# SERVICE No. 177 BULLETIN

Piper Aircraft Corporation

**SUBJECT:** Fuel Cell Filling Instructions

**MODELS AFFECTED:** PA-24 and PA-24 "250"  
Serial Numbers 24-1 to 24-1264 inclusive

FUEL PLACARD DETAIL  
(ON PA-24 ONLY)

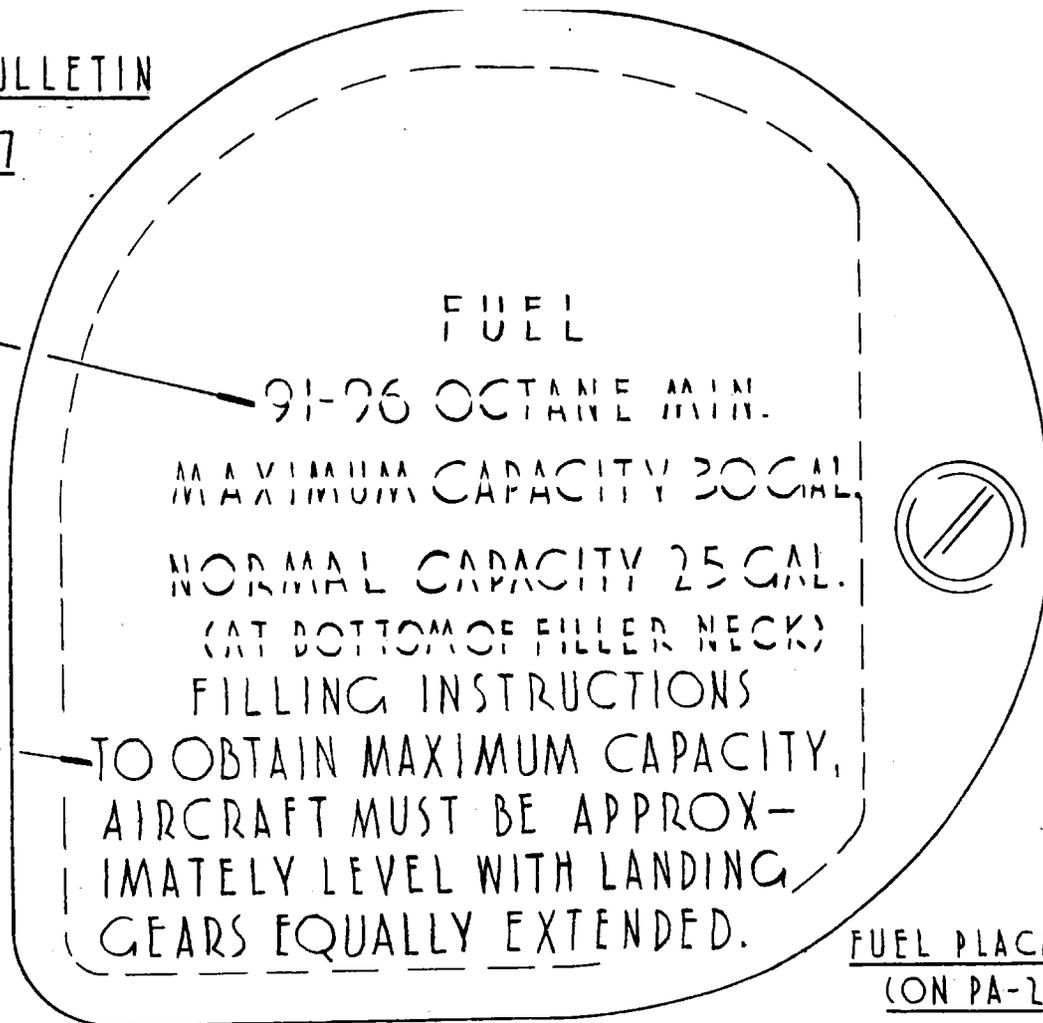
The above mentioned airplanes shall have a Fuel Cell Filling Instructions placard added to the left and right fuel cell filler neck cover plate during the next 100 hour periodic inspection. These instructions indicate the proper method of obtaining the maximum fuel tank capacity of thirty (30) gallons per tank.

Apply this placard per sketches shown on the reverse side of this bulletin by bending a corner of the placard sharply and peeling the film from the backing. Ascertain that the metal surface is clean and dry before placing the placard in the desired position and smoothing out with a squeegee.
